# Attachment 1 – Roadway System Refinement Details

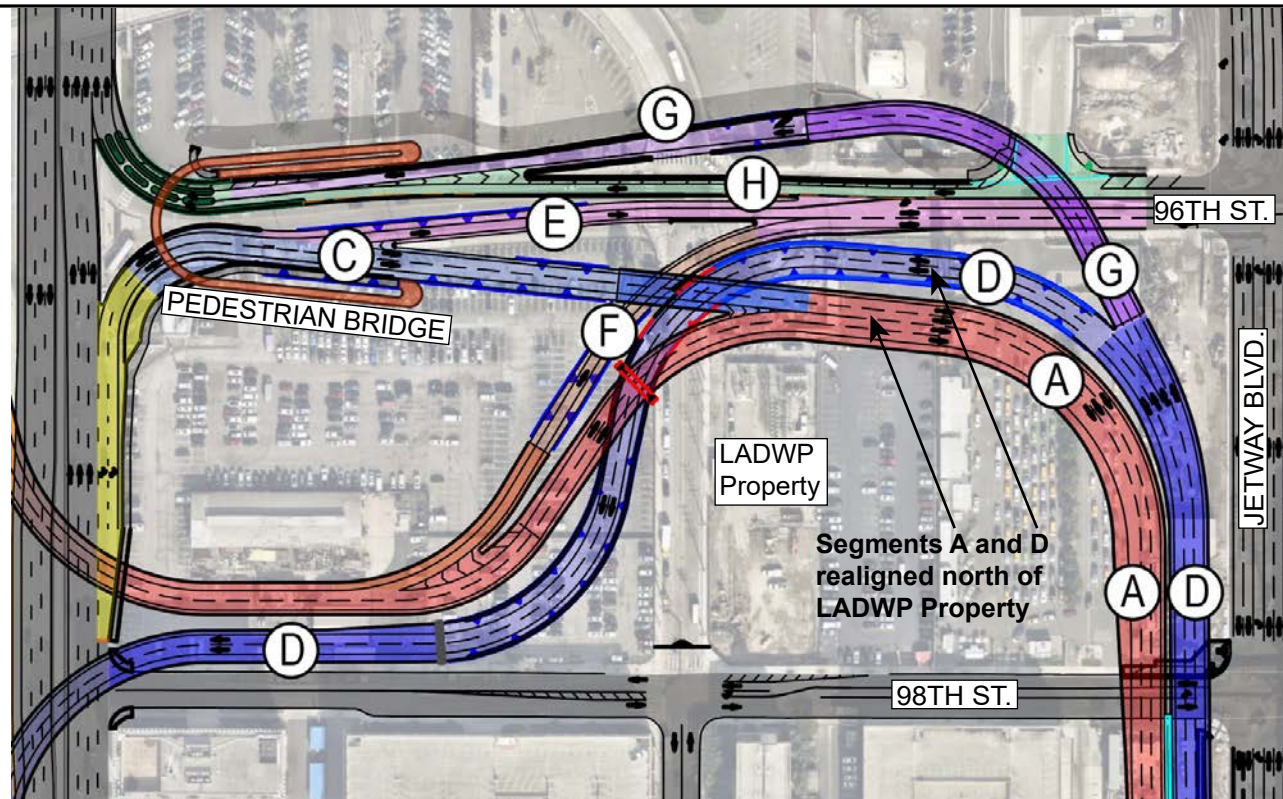
**Image 1:** Between Jetway Boulevard and Sepulveda Boulevard, roadway Segments A and D would be realigned to avoid the LADWP property; the realignment would also reduce operational impacts on the Sunrise Parking property.

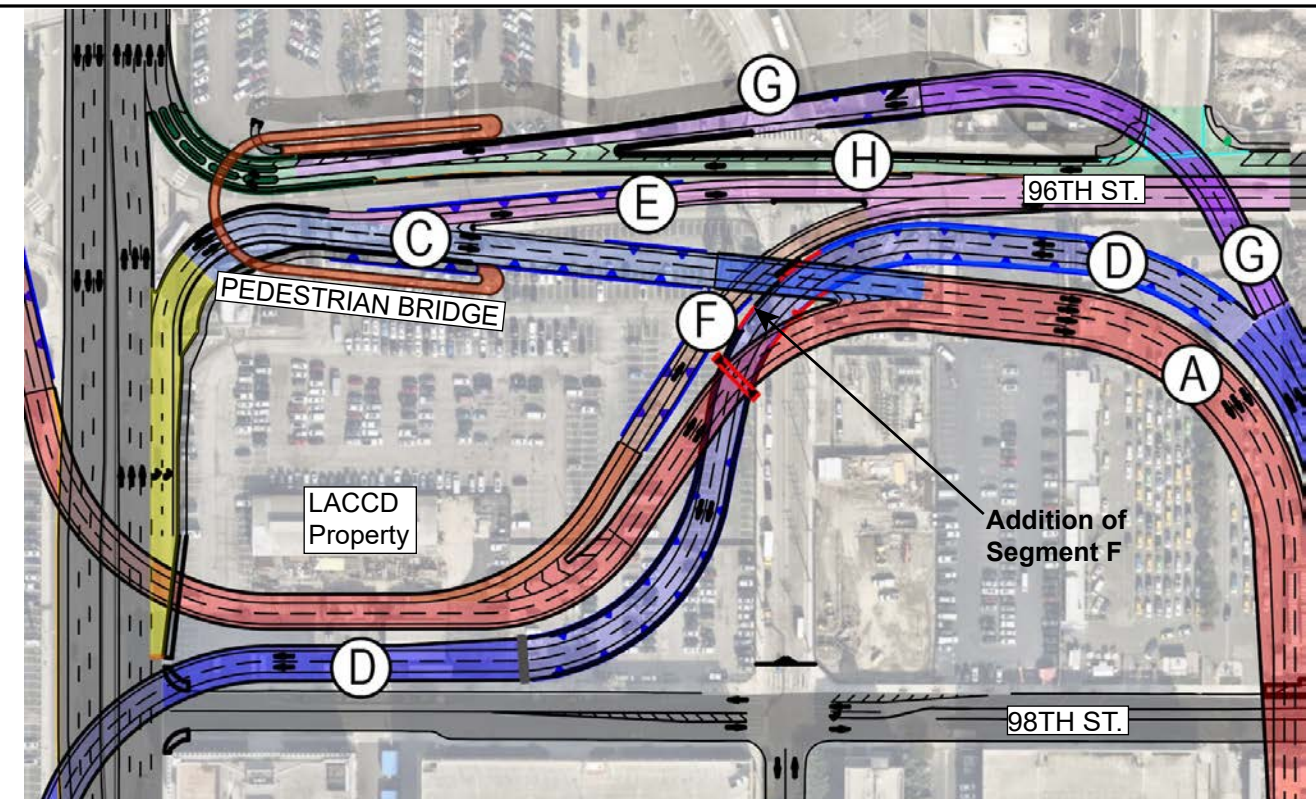
**Image 2:** Segments A and D realignments and addition of Segment F (Figure 1B, Image 6) would require additional property acquisition at the LACCD property.

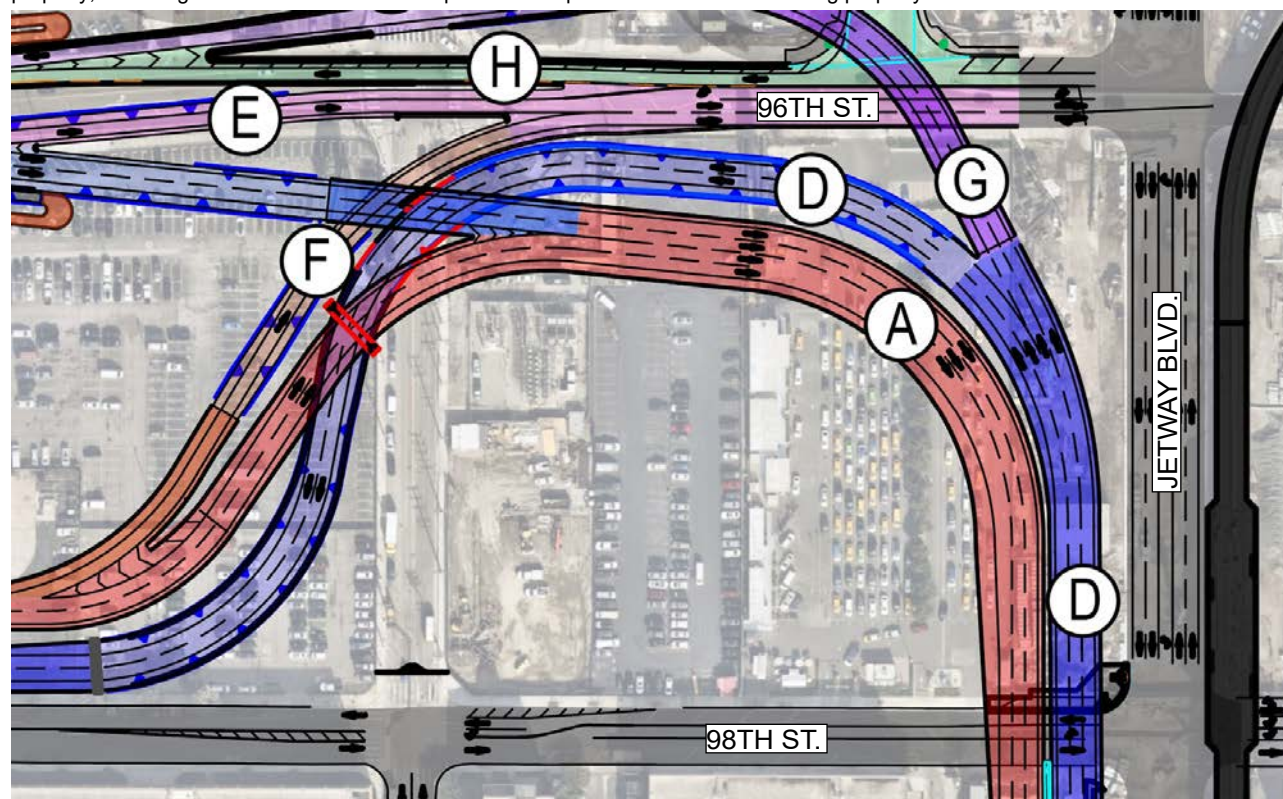
**Image 3:** The connection from Segment G to 96th Street eastbound (via Segment F) under the Approved Roadway System, which would have also provided access to Jetway Boulevard, would be eliminated. Under the Proposed Roadway System Refinements, outbound access from the Central Terminal Area to Jetway Boulevard would be provided by Century Boulevard via Segments P and R, shown in Image 10.

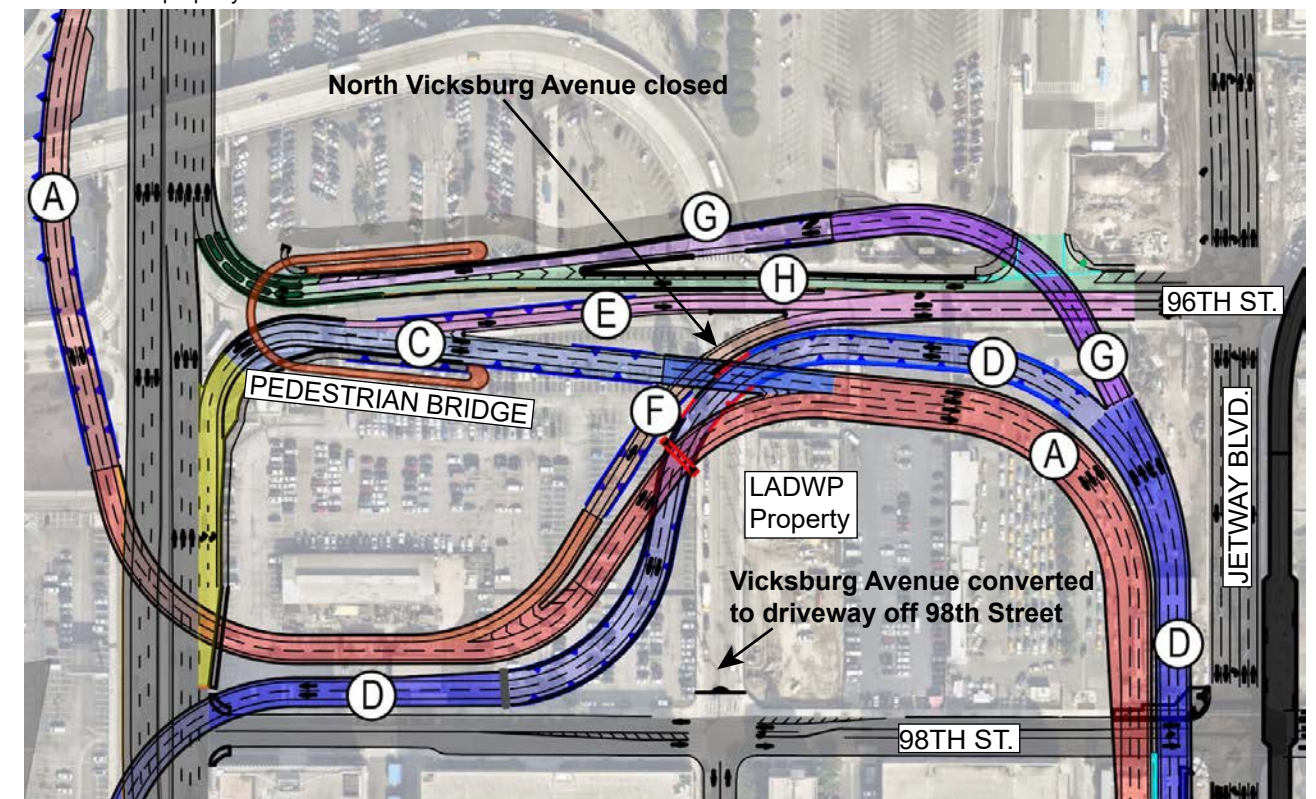
**Image 4:** Through access on Vicksburg Avenue between 96th Street and 98th Street would be eliminated; the connection between Vicksburg Avenue and 96th Street would be removed and the remaining southern section of Vicksburg Avenue would be converted to a driveway for LADWP property. The driveway entrance would be from 98th Street.

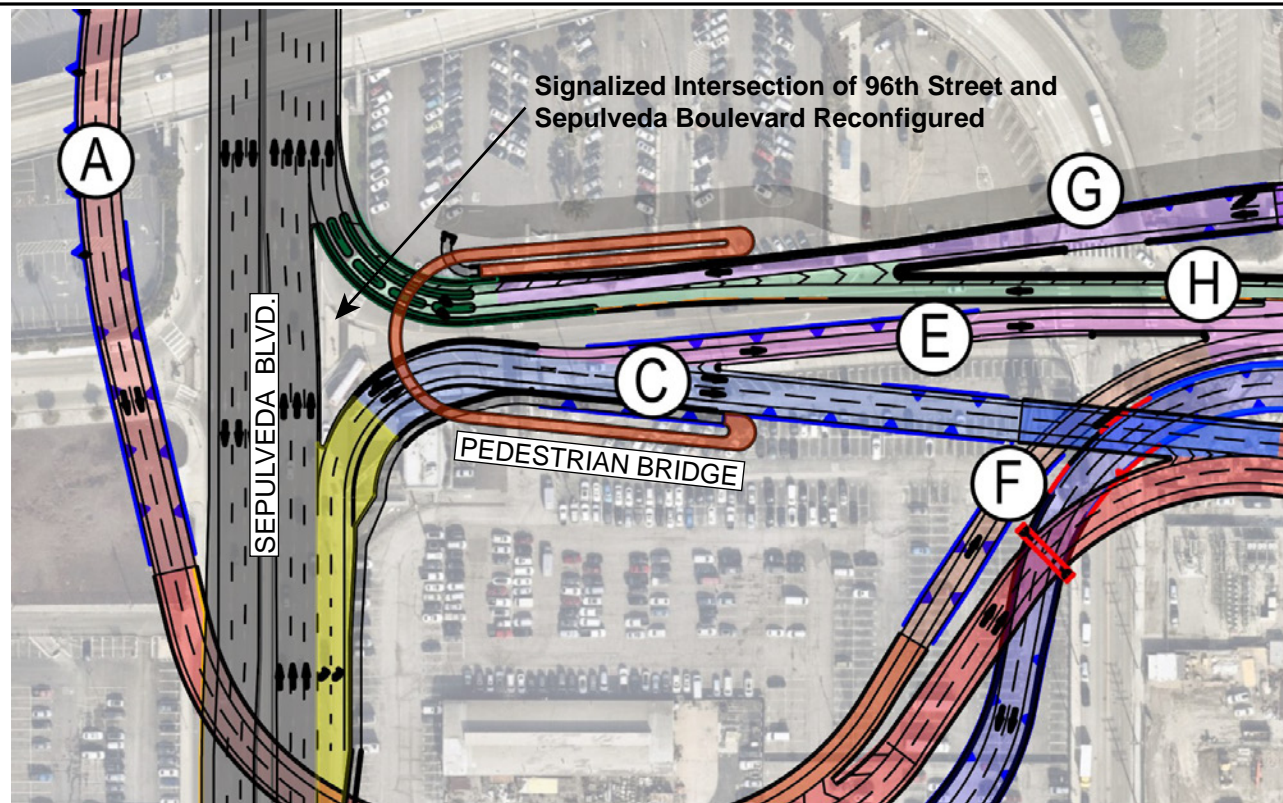
**Image 5:** Intersection of 96th Street and Sepulveda Boulevard would be reconfigured to eliminate the need for future signalization of the intersection, which would result in improved operations on Sepulveda Boulevard compared to a signalized intersection (i.e., reconfiguration would eliminate the need for a signal to enable SB traffic on Sepulveda Boulevard to turn left for EB travel on 96th Street); reconfiguration would include additional turning lanes on Sepulveda Boulevard.

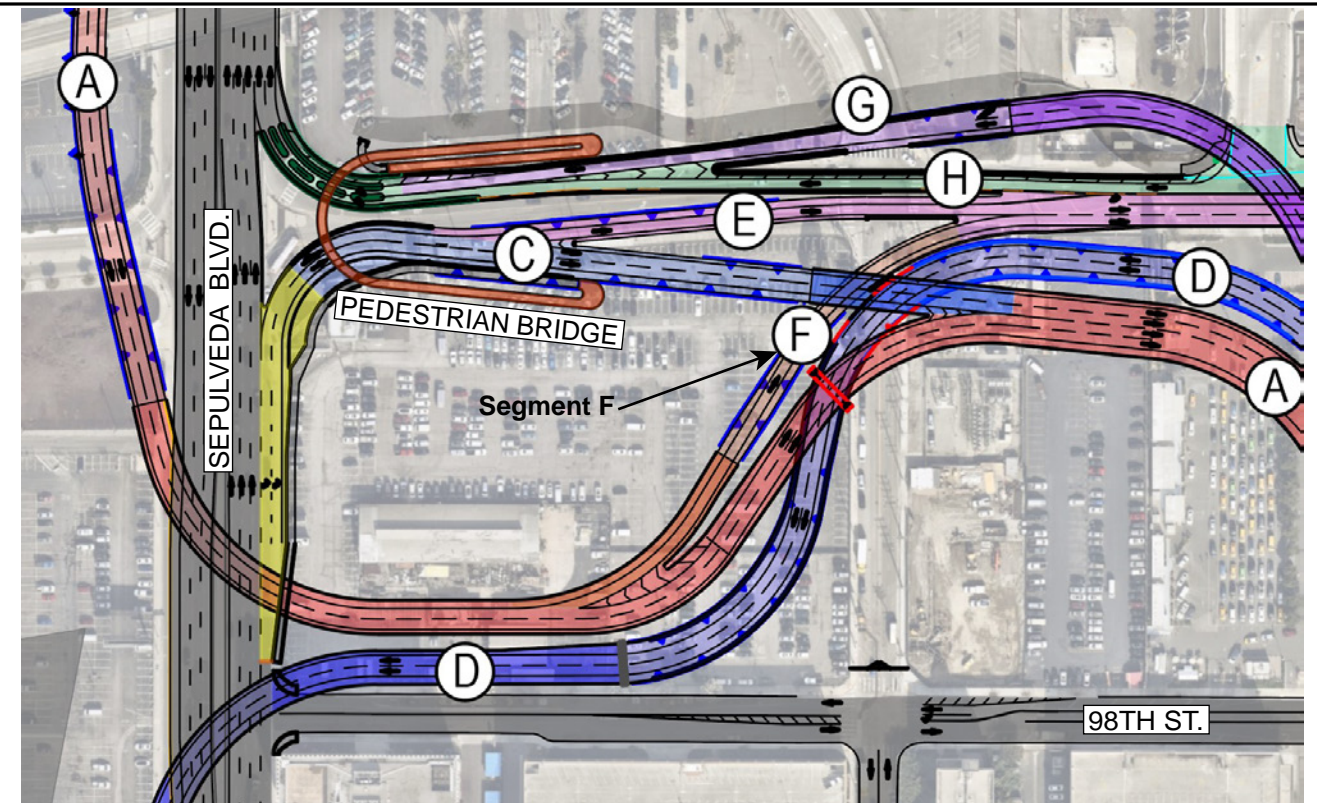
**Image 6:** The eastern portion of Segment F would be relocated/reconfigured to be an offramp from Segment A and connect to EB 96th Street. With Segment A being elevated above Sepulveda Boulevard, this would enable movement from Sepulveda Boulevard southbound to 96th Street eastbound to occur without the need to install a traffic signal at Sepulveda Boulevard and 96th Street.

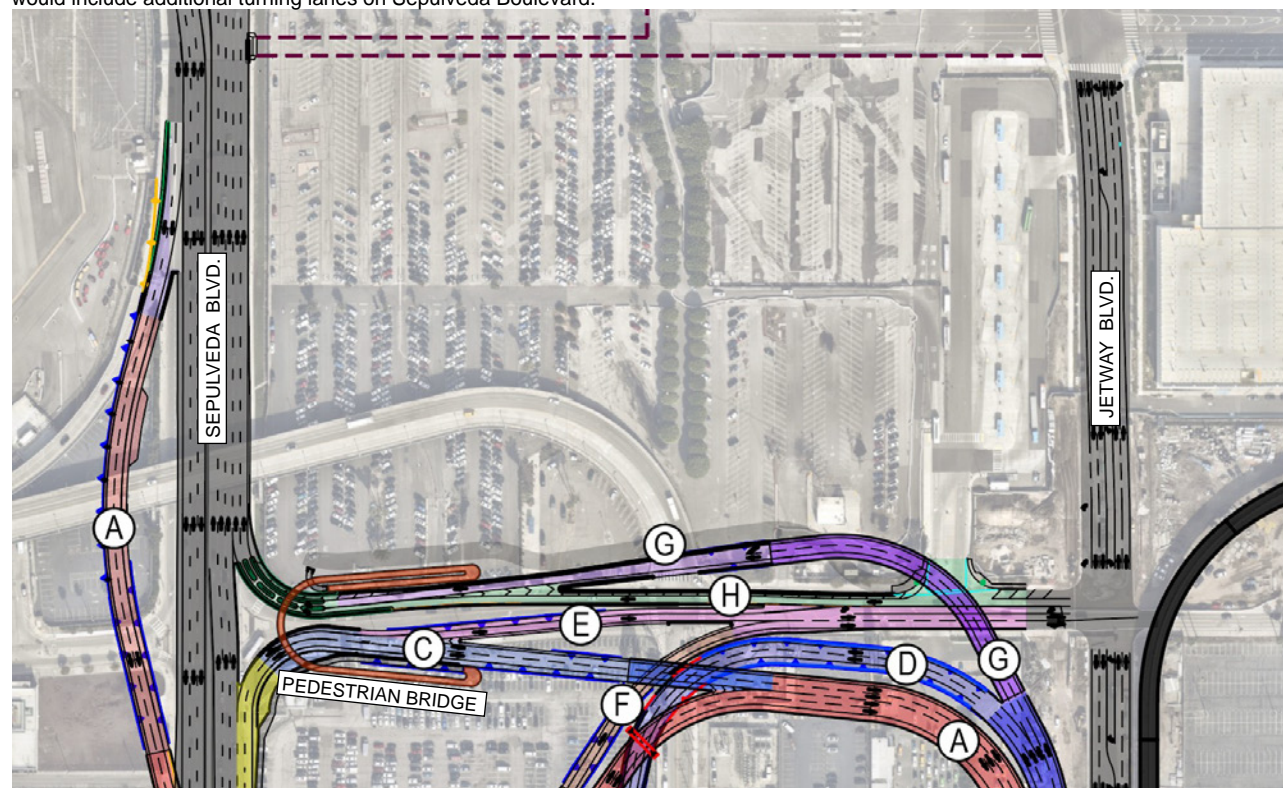
**Image 7:** A pedestrian bridge would be added over 96th Street east of Sepulveda Boulevard.

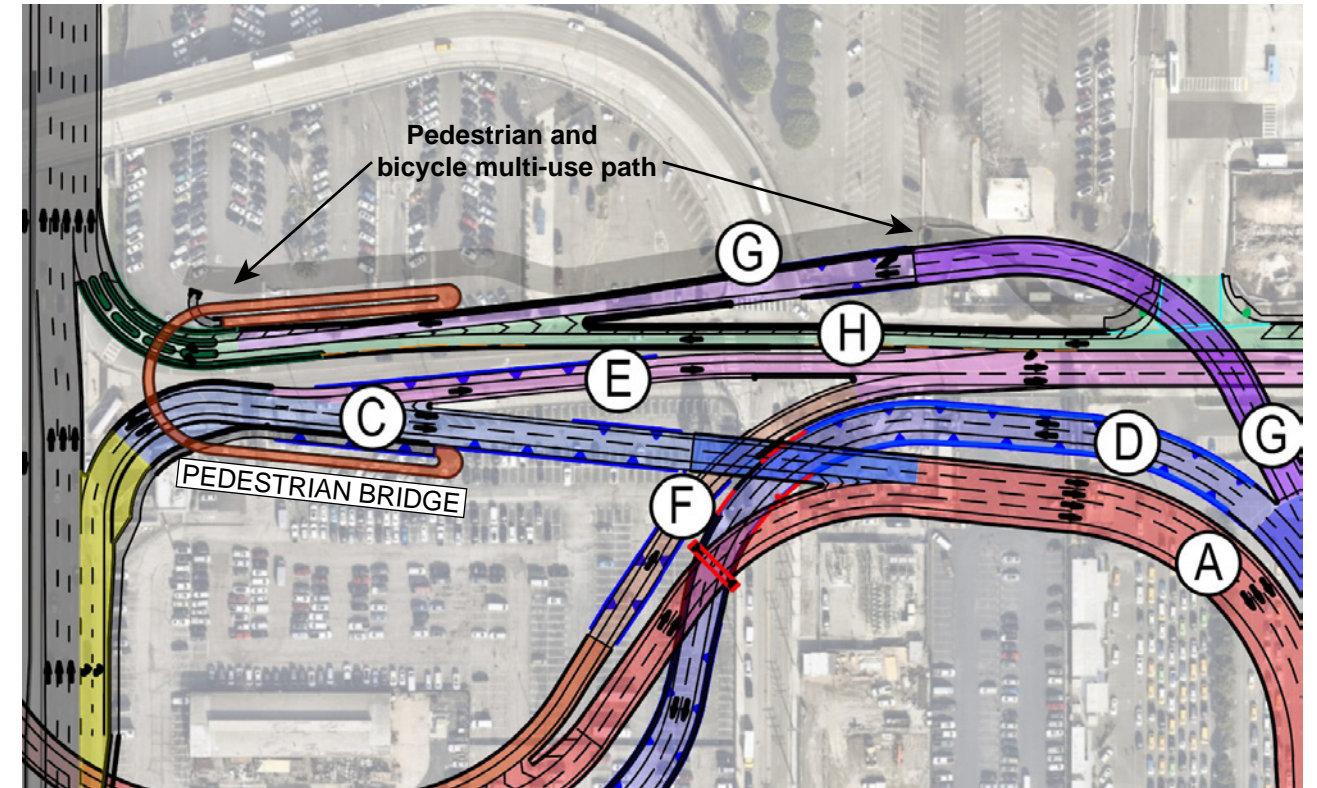
**Image 8:** A pedestrian and bicycle multi-use path would be added along 96th Street westbound from Jetway Boulevard to Sepulveda Boulevard.

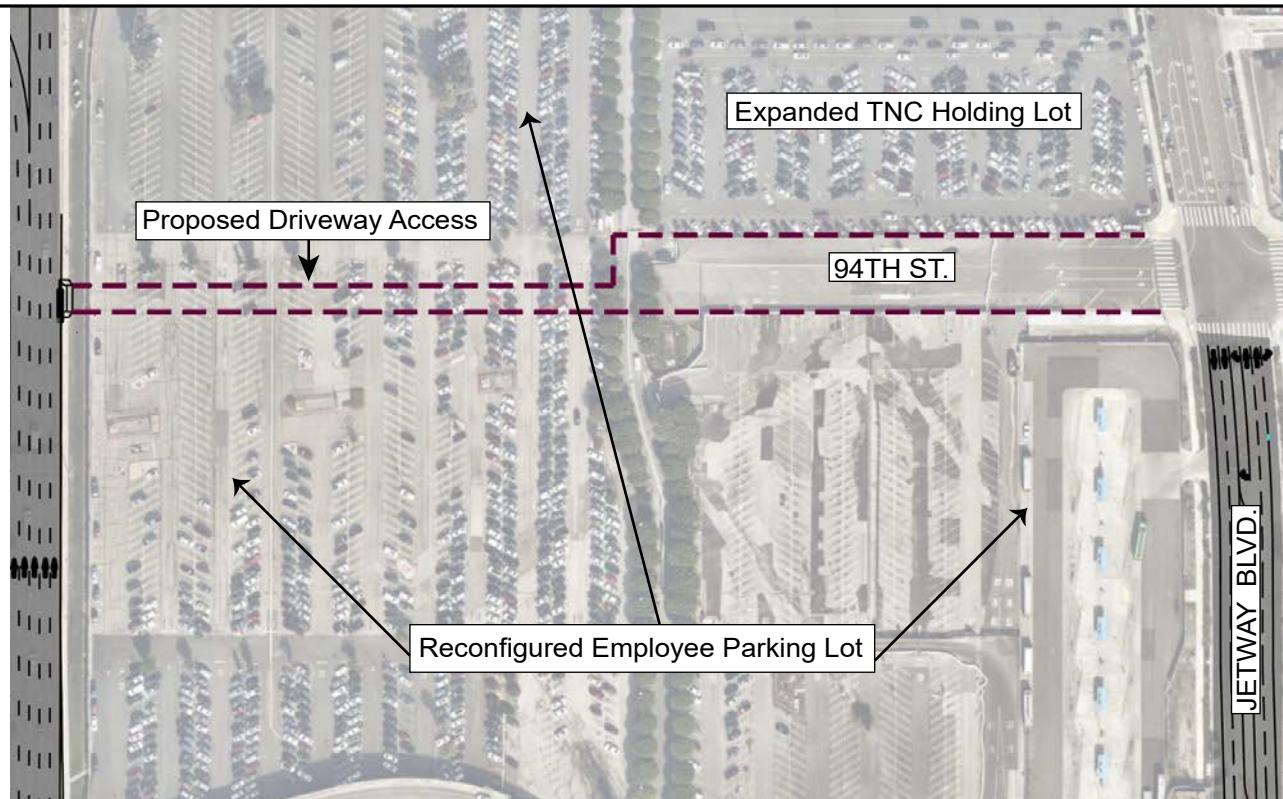
**Image 9:** A new driveway access would be provided from northbound Sepulveda Boulevard to the east in line with 94th Street. The existing parking lot/vehicle staging areas would be reconfigured as follows: the areas south of 94th Street and in the northwestern quadrant would be used for employee parking; the northeastern quadrant would house the expanded TNC Holding Lot and, to the north of that, the relocated LAX Taxi Staging Lot (not shown). The existing airport shuttle/limousine staging area would be relocated to the northeast corner of Airport Boulevard and 96th Street (not shown).

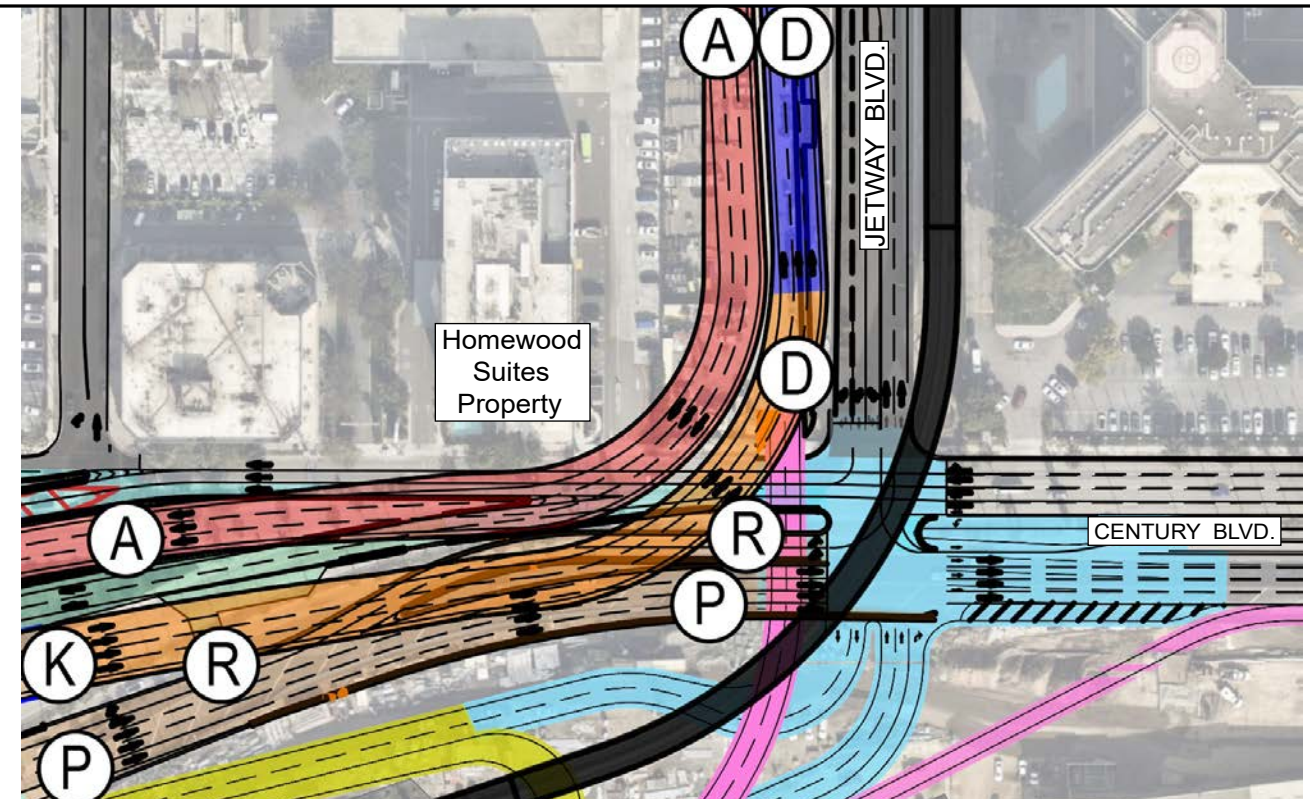
**Image 10:** An aerial easement would be required at the Homewood Suites property to enable the elevated roadway structure.
